PROJECT NAME: PERU
 PROJECT NUMBER: STP SCRP(4)
 FILE NAME: z07b106ut11bdr.dgn
 PROJECT LEADER: E. ATKINS
 DESIGNED BY: M. BRADLEY
 UTILITY PLAN SHEET

PLOT DATE: 12/31/2014
 DRAWN BY: M. BRADLEY
 CHECKED BY: E. ATKINS
 SHEET 28 OF 45

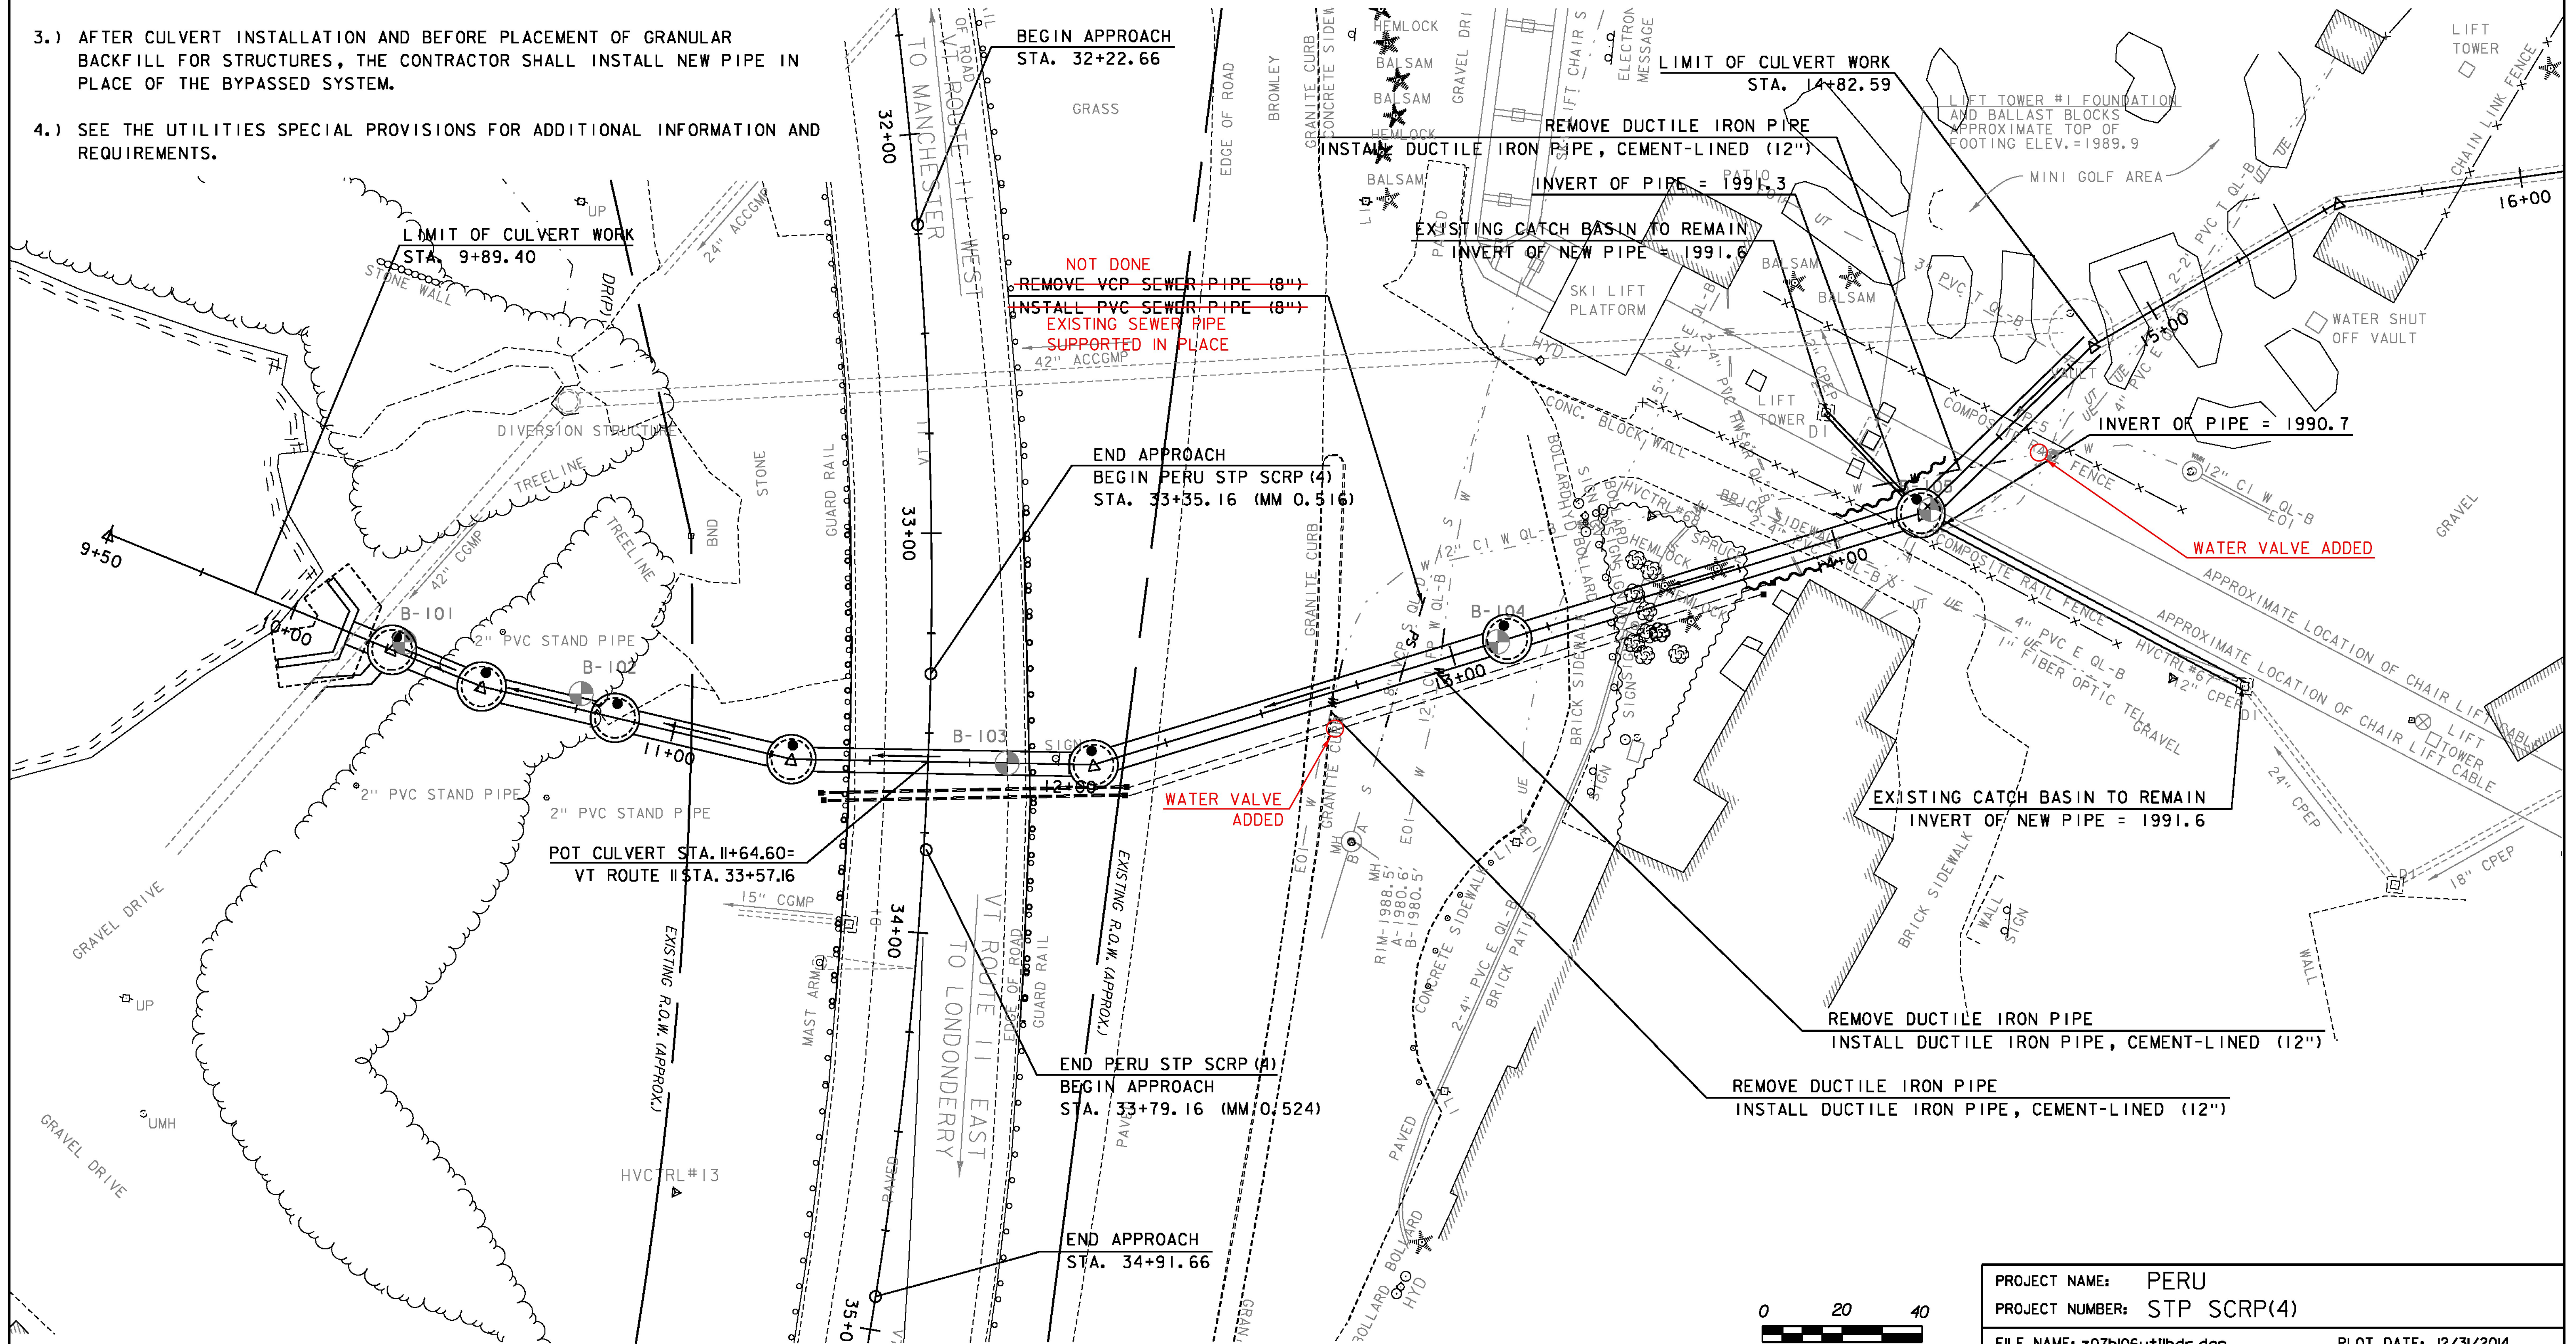
~~PVC SEWER PIPE (8") (PARTICIPATING)~~
~~12+76.2 RT - 12+97.7 LT NOT DONE~~

~~NOT DONE~~
~~REMOVE VCP SEWER PIPE (8")~~
~~INSTALL PVC SEWER PIPE (8")~~
 EXISTING SEWER PIPE SUPPORTED IN PLACE

WATER VALVE ADDED

WATER VALVE ADDED
